SERVICE BULLETIN

Classification: ST12-009b	Reference: NTB13-017b	Date: August 28, 2013
------------------------------	--------------------------	--------------------------

2013 ALTIMA SEDAN; NOISE FROM THE HYDRAULIC ELECTRIC POWER STEERING (H-EPS)

This bulletin has been amended. On pages 15 and 16, “For vehicles built after the applied VIN and date” was changed to “For vehicles built before the applied VIN and date”. Please discard previous versions of this bulletin.

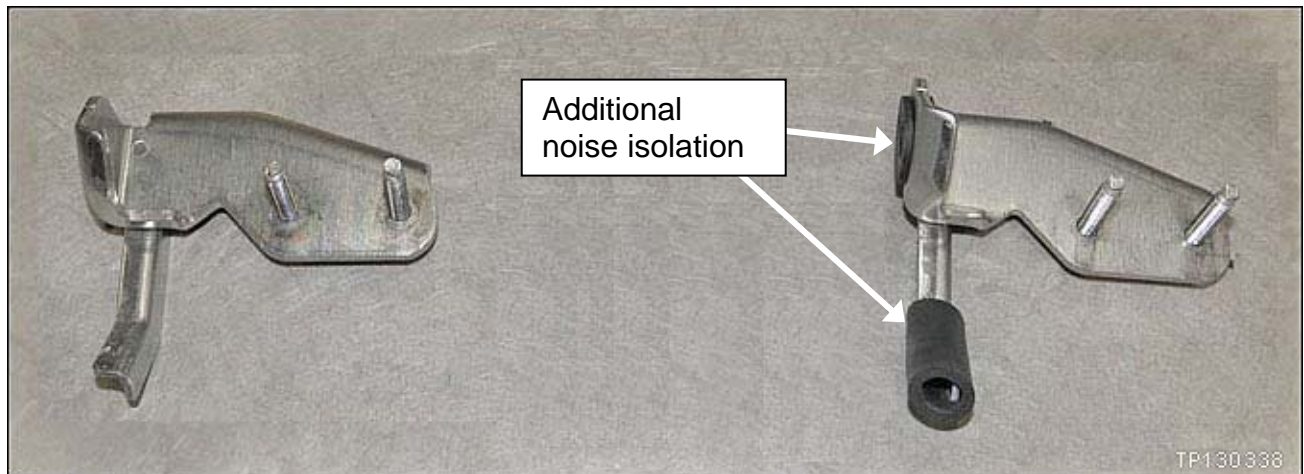
Old style bracket

New style bracket

DESCRIPTION	PART NUMBER	QUANTITY
BRACKET * (H-EPS Bracket)	49730 – 3TA0D	1: If needed.
SEAL ASSY * (Hood Ledge Seal)	65820 – 3TA0A	1: If needed.
COVER-BODY, TANK * (H-EPS Pump Felt Cover)	49184 – 3TA0A	1: If needed.
PROTECT FR FND R * (Right Front Fender Protector / Includes Noise Insulator)	63840 – 3TA0D	1: If needed.
BAFFLE FRONT FENDER, LOWER RH * (Baffle)	63134 – 3TA0A	1: If needed.
HOSE CONTL VALV (H-EPS High Pressure Line – 4 Cyl Only)	49720 – 3TA0C	1: If needed.

Figure 17

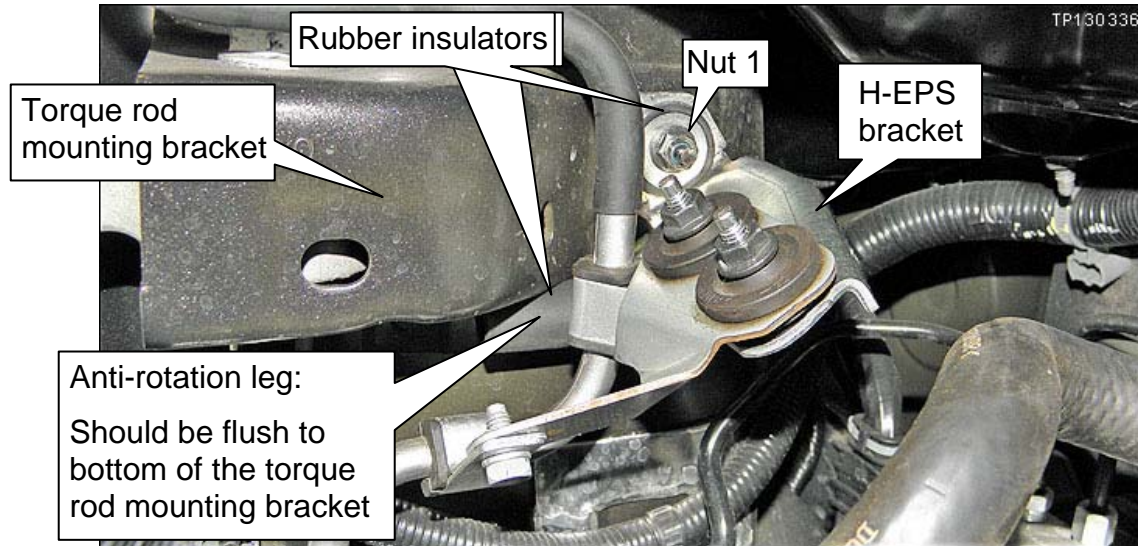
16. Make sure the anti-rotation leg of the H-EPS bracket is flush to the bottom of the torque rod mounting bracket (see Figure 17 and 18 as they apply).

17. Check the torque of Nut 1.

1a. Remove the 3 nuts shown in Figure 17.

3a. Reinstall the 3 nuts and torque to:

Nut 1: 8 N•m (0.81 kg-m, **5.9 ft-lb, 71 in-lb**)

Nut 2 & 3: 4.9 N•m (0.49 kg-m, **3.6 ft-lb, 43 in-lb**)

Figure 19

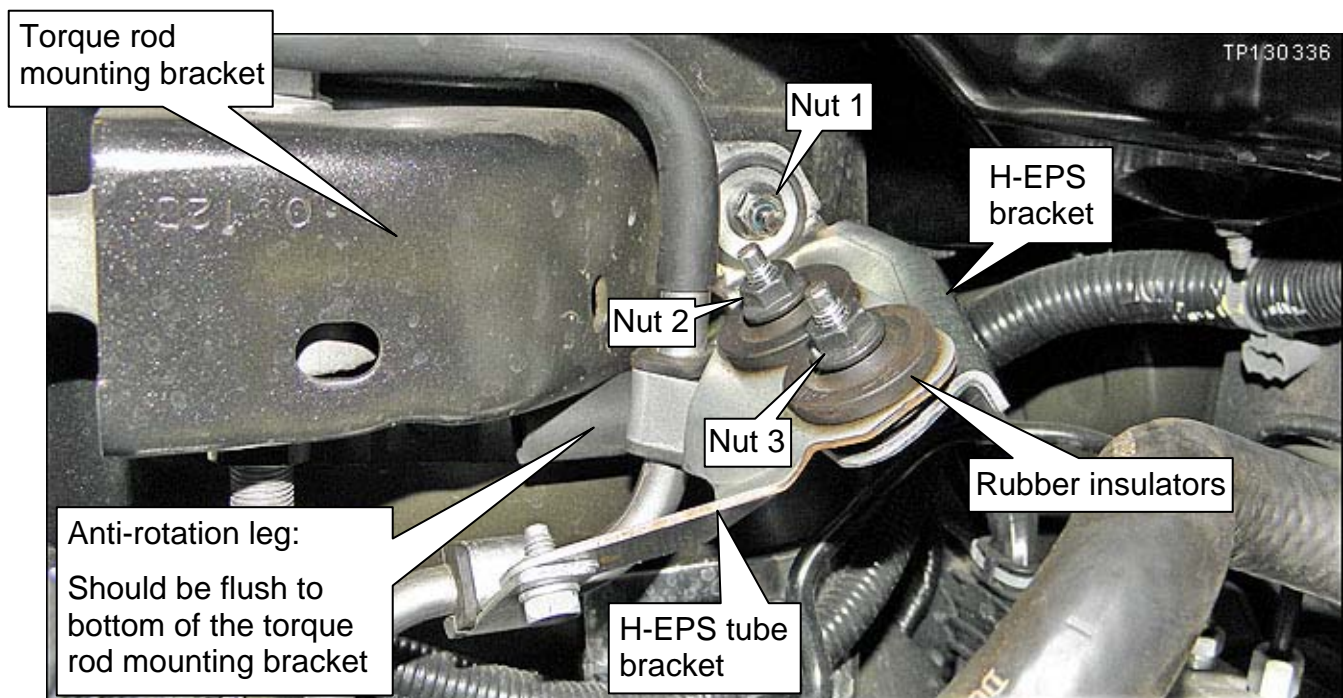
4a. Make sure the H-EPS bracket and the H-EPS tube bracket are not touching (see Figure 19).

- There should be a gap between the brackets all the way around.
- Make sure the rubber insulators are seated properly.
- If needed, reposition the brackets so they are not touching.

5a. Make sure the anti-rotation leg of the H-EPS bracket is flush to the bottom of the torque rod mounting bracket (see Figure 19).

- If needed, reposition the H-EPS bracket so the anti-rotation leg is flush to the bottom of the torque rod mounting bracket.

Figure 20

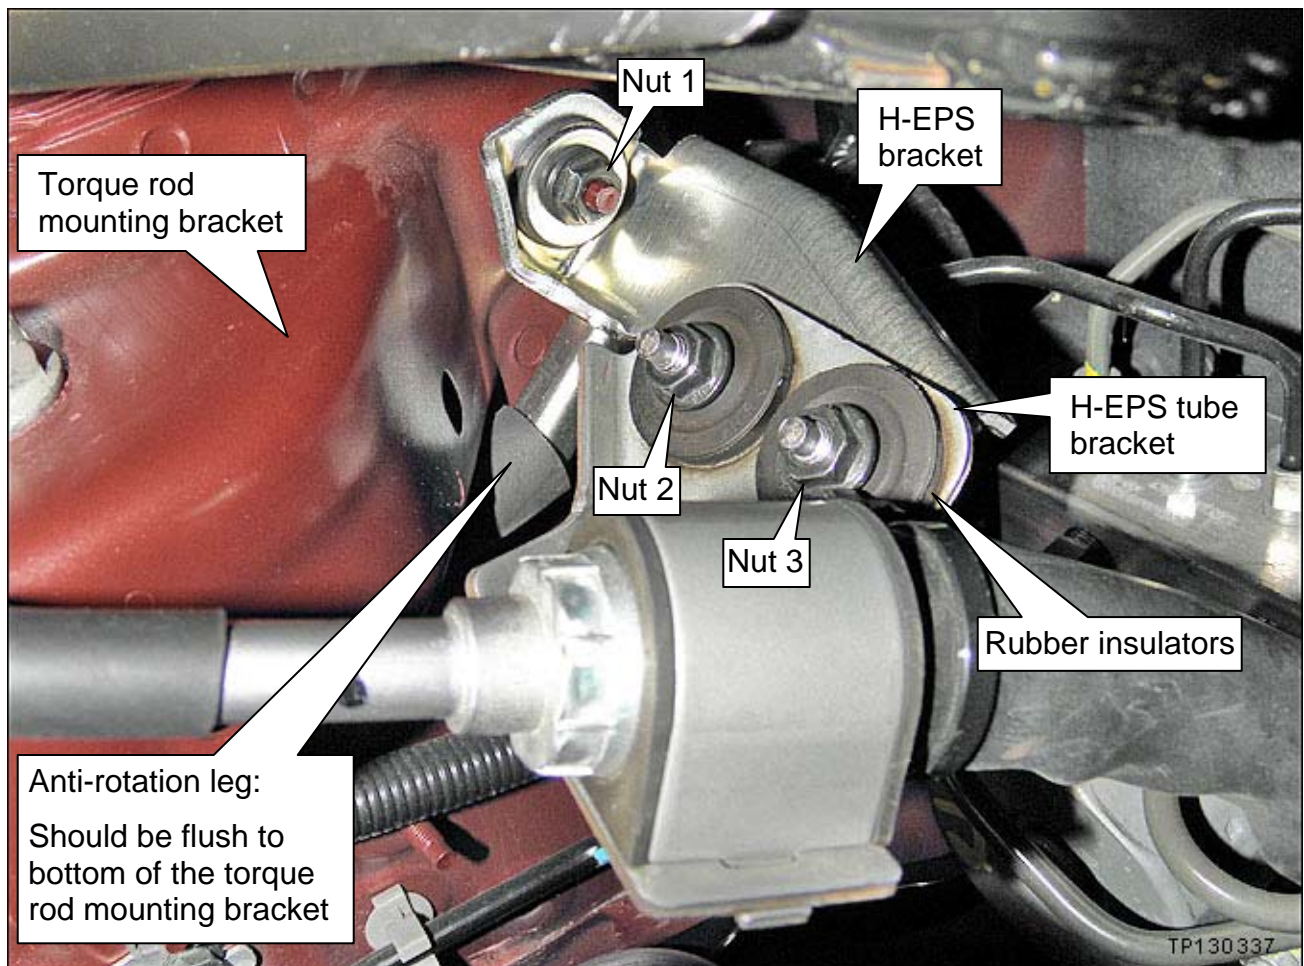
- 1b. Remove the 3 nuts shown in Figure 1.
- 2b. Remove the old bracket and install the new bracket.
- 3b. Reinstall the 3 nuts and torque to:

- 4b. Make sure the H-EPS bracket and the H-EPS tube bracket are not touching (see Figure 19).
 - There should be a gap between them, all the way around.
 - Make sure the rubber insulators are seated properly.
 - If needed, reposition the brackets so they are not touching.
- 5b. Make sure the anti-rotation leg of H-EPS bracket is flush to the bottom of the torque rod mounting bracket (see Figure 18).
 - If needed, reposition the H-EPS bracket so the anti-rotation leg is flush to bottom of the torque rod mounting bracket.

Nut 1: 8 N•m (0.81 kg-m, **5.9 ft-lb, 71 in-lb**)

Nut 2 & 3: 4.9 N•m (0.49 kg-m, **3.6 ft-lb, 43 in-lb**)
